UNITED STATES DEPARTMENT OF THE INTERIOR BUREAU OF LAND MANAGEMENT

1. Type of Well ☐ ☐ Gas Well ☐ ☐ C	8. Well Name and No.		
2. Name of Operator Matador Production Company	Shoot 12 Federal #3		
a. Address	3b. Phone No. (include area-code)	9. API Well No. 30-025-31101	
PO BOX 1936 ~ ROSWELL NM 88202-1936	3b. Phone No. (include area code) 575.623.660 ECEIVED	10. Field and Pool, or Exploratory Area Corbin;Grayburg West

Tbg: 125 jts 2 3/8" tbg Rods: 160 Proposed Wellbore Diagram after Recomplete

Shoot 12 Federal 3 30-025-31101 Matador Production Company February 12, 2016 Conditions of Approval

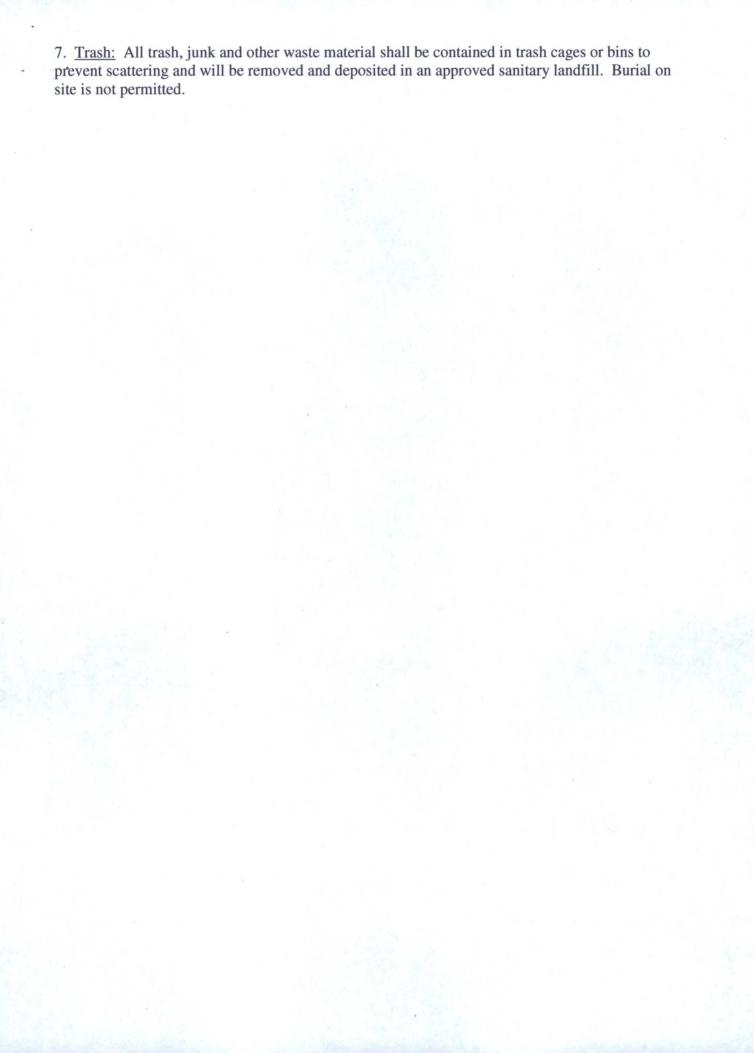
- 1. Operator shall place CIBP at 4,688' (50'-100' above top most perf) and place 35' of Class H cement on top. WOC and tag.
- 2. Must conduct a casing integrity test before perforating and fracturing. Submit results to BLM. The CIT is to be performed on the production casing to max treating pressure. Notify BLM if test fails
